# UNITED STATES PATENT AND TRADEMARK OFFICE

| APPLICATION NO.  | FILING DATE | FIRST NAMED INVENTOR | ATTORNEY DOCKET NO.             | CONFIRMATION NO.       |
|--|-------------|----------------------|---------------------------------|------------------------|
| 10/756,775   | 06/14/2004  | Felix L. Sorkin      | 1101-175                        | 3115                   |

## Office Action Summary

## **DETAILED ACTION**

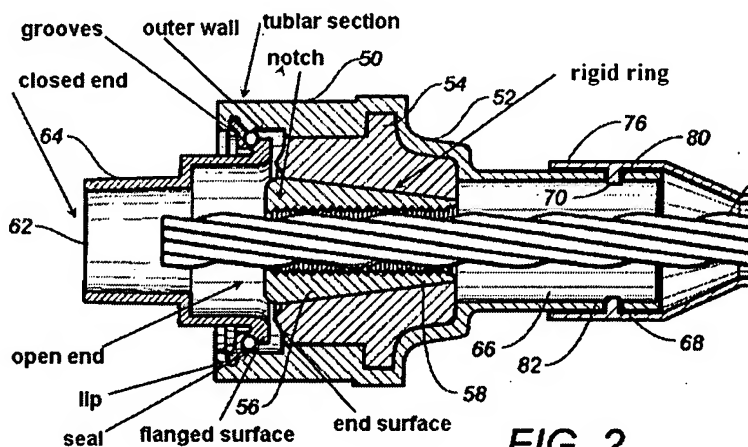
7. In Re claim 10, Figure 2 (See modified Figure 2 above) of Sorkin discloses a tubular body having an open end and a closed end; and a flanged surface extending radially outwardly of said tubular body at said open end, said flanged surface having an end surface and an outer wall extending outwardly therefrom, said outer wall having a lip formed at an end of said outer wall opposite said end surface, said lip projecting radially outwardly from said outer wall.

10. In Re claim 14, Figure 2 (See modified Figure 2 above) of Sorkin discloses an anchor member (54) having an end surface; a polymeric encapsulation covering (Column 4 Lines 1-17) said anchor member (54), said polymeric encapsulation having a tubular section extending outwardly of said end surface; a rigid ring affixed within said tubular section, said rigid ring having a notch formed on an inner wall thereof.

12. In Re claim 17, modified Figure 2 of Sorkin discloses a notch comprising a first notch formed around said inner wall of said rigid ring adjacent an end of rigid ring opposite said end surface of said anchor member.

13. In Re claim 18, modified Figure 2 of Sorkin discloses a notch further comprising a second notch formed around said inner wall of said rigid ring adjacent an opposite end of said rigid ring, said second notch being in spaced parallel relationship to said first notch. Examiner is considering the second notch to be one of the many other indentions on what has been labeled the rigid ring in the figure above.

14. In Re claim 19, modified Figure 2 of Sorkin discloses a rigid ring having a tapered surface at an end thereof adjacent an end of said tubular section of said polymeric encapsulation opposite said end surface of said anchor member.

15. In Re claim 20, modified Figure 2 of Sorkin discloses a tendon (74) affixed to said anchor member (54), said tendon (74) having an end extending outwardly of said end surface of said anchor member (54).
